Job Sheet R198349

Part No: D4842-4

Part Name: Lower Cutter Body, RH

WORK ORDER NON-CONFORMANCE / ROUTE UPDATE

D4842-4 LOWER CUTTER BODY RH
(AUXILIARY VIEW)

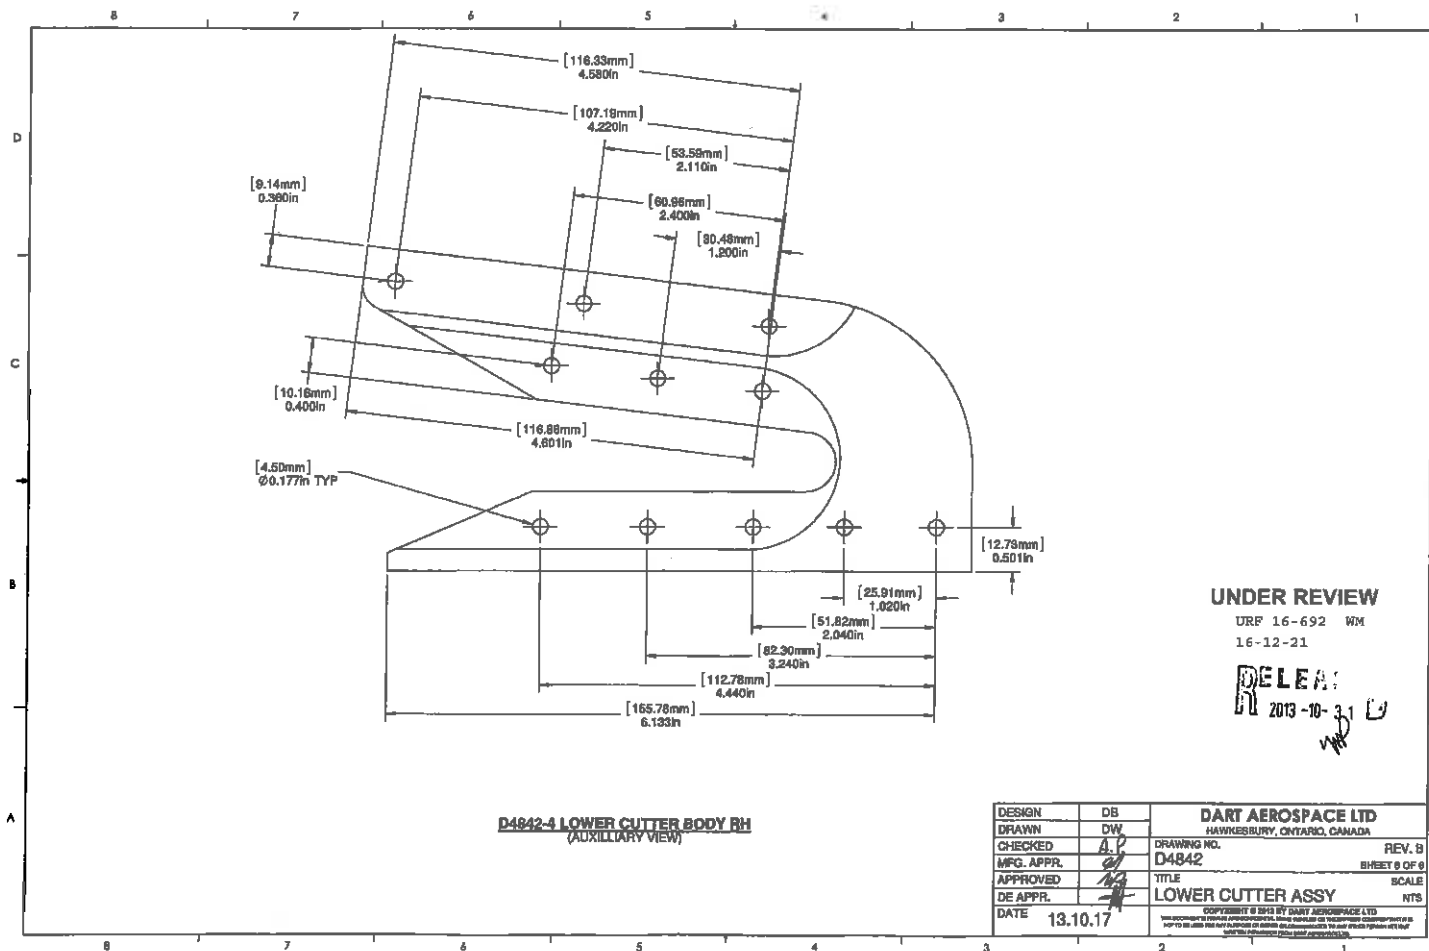
- Remove 0.005 of material from base face to the following D4842-4 (See attached Drawing) measurement should be 0.425 +0.000 -0.008

Re-work D4842-4 as per attached instruction / drawing
